- Request - Special Use Permit for Tobacco Shop
- Location - 27 S. Reynolds Road
- Applicant - Lava Francis
Wild Bills of Toledo VII, LLC
1100 W. Maple Road
Troy, MI 48084
- Owner - Reynolds & Hill Plaza X LLC
6725 W Central Avenue, Unit U
Toledo, OH 43617
- Architect - Engineers, Surveyors & Associates LLC
5353 Secor Road
Toledo, OH 43623

The staff recommends that the Toledo City Plan Commission recommend approval of SUP-6003-24, a Special Use Permit for a tobacco shop at 27 S. Reynolds Road, to Toledo City Council for the following two (2) reasons:

SPECIAL USE PERMIT
TOLEDO CITY PLAN COMMISSION
REF: SUP-6003-24
DATE: July 11, 2024
TIME: 2:00 P.M.

SITE PLAN

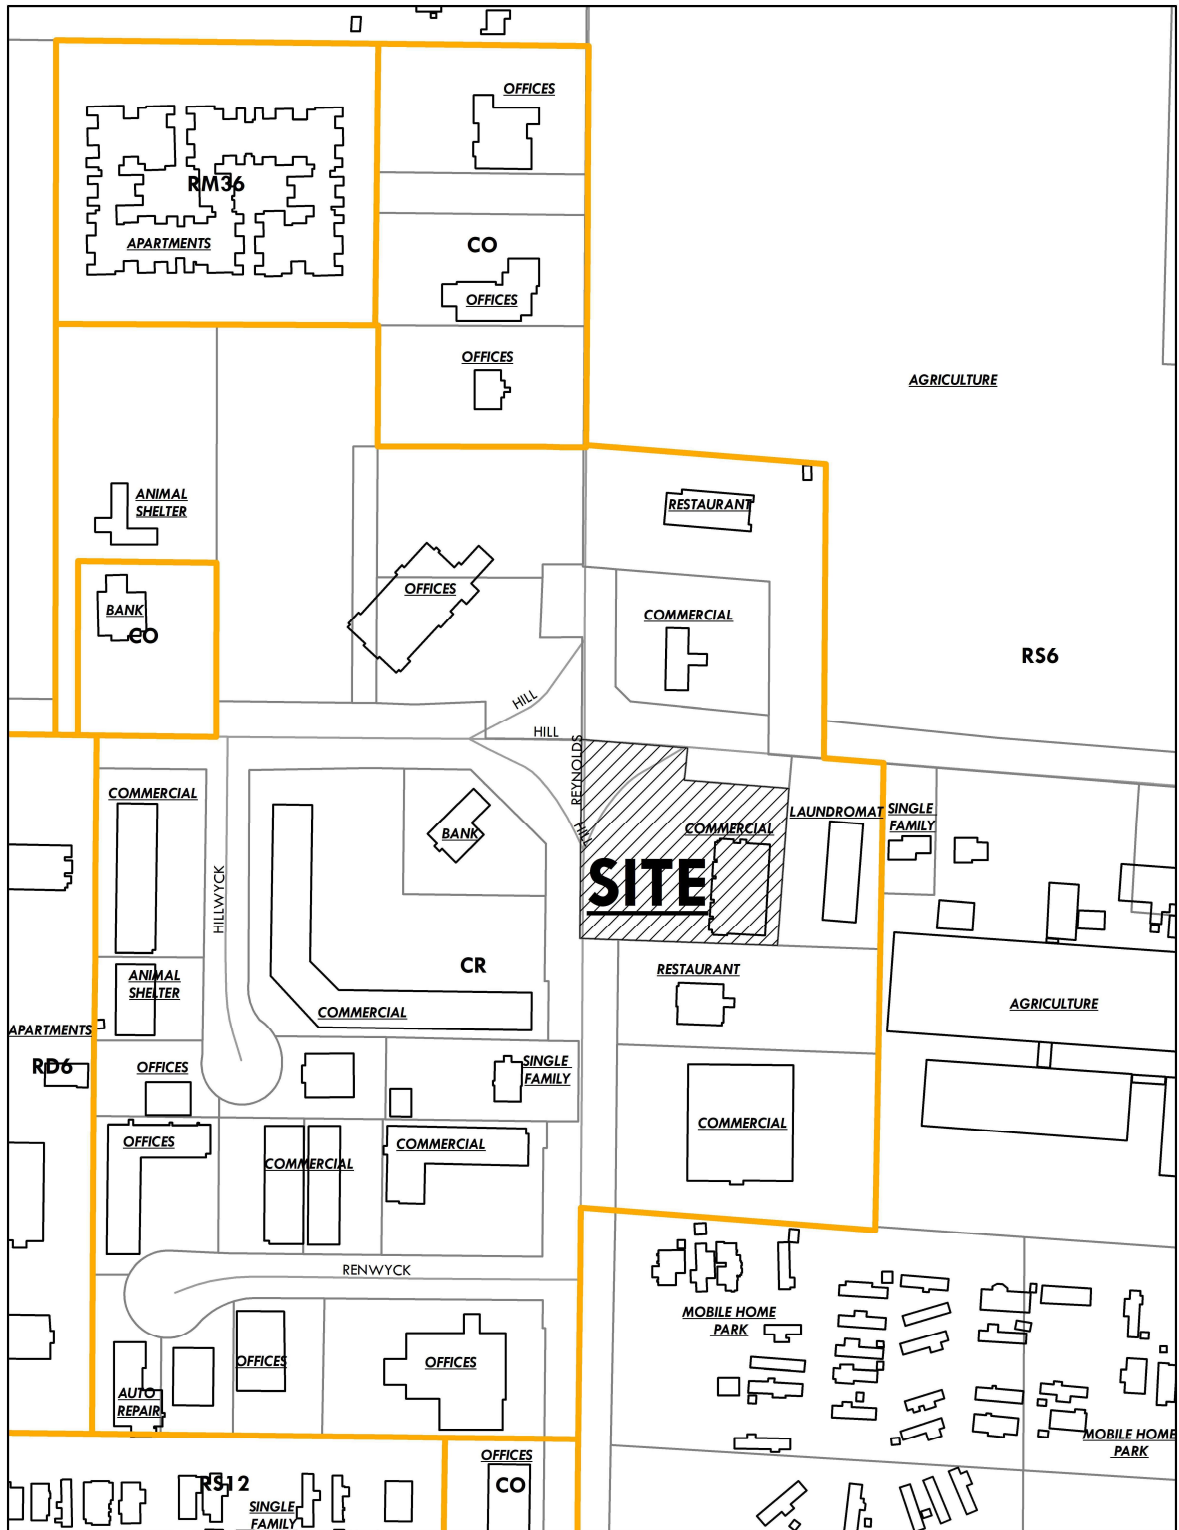
19. Bicycle parking is required pursuant to Off-Street Parking Schedule “A” (TMC§1107.0300). A minimum of one (1) bicycle space shall be provided per ten (10) parking spaces. **This is not acceptable as depicted. A revised site plan depicting a bicycle rack for six (6) bicycles shall be provided.**

- a. Per TMC§1108.0202, a fifteen-foot (15’) greenbelt is required along the property line fronting Reynolds Road and Hill Avenue. At least one tree must be provided for every thirty feet (30’) of lot frontage or fraction thereof. The frontage greenbelt shall also include a solid evergreen hedge to screen parking in the front of the property and prevent headlights from being seen from the right-of-way. Seven (7) trees and a continuous shrub shall be provided along Reynolds Road. The same number of trees and a continuous shrub is required along Hill Avenue. The submitted site plan shows three (3) trees and shrubs along a portion of both Hill Avenue and Reynolds Road. **This is not acceptable as depicted. A revised site plan depicting the required trees and shrubs along all parking spaces in the front shall be submitted;**

- b. Two (2) canopy trees and six (6) shrubs are required to be installed in interior landscape areas for each ten (10) parking spaces. A total of ten (10) trees and thirty (30) shrubs are required in the interior parking. The submitted site plan shows the required landscape islands with a total of four (4) trees and seventeen (17) shrubs. **This is not acceptable as depicted. A revised landscape plan depicting the additional required trees and shrubs shall be submitted;**

- c. Landscape areas within the parking area must be peninsular or island types and must be constructed with six-inch by eighteen-inch (6"x18") concrete curbing, cast-in-place, extruded, or by some other process approved by the Planning Director. **This is acceptable as depicted;**
